Service Bulletin

Bulletin No.: 20-NA-105

Subject: 360 Camera Views go Blank with Tailgate Removed

5608157

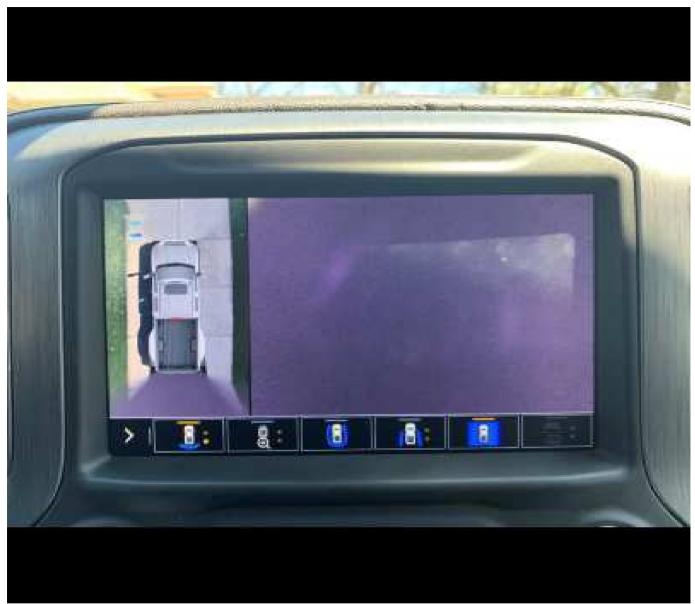
Below are examples of camera views with the tailgate equipped normally and tailgate removed with camera covered.

Frontend view, Tailgate equipped

Frontend view, Tailgate removed
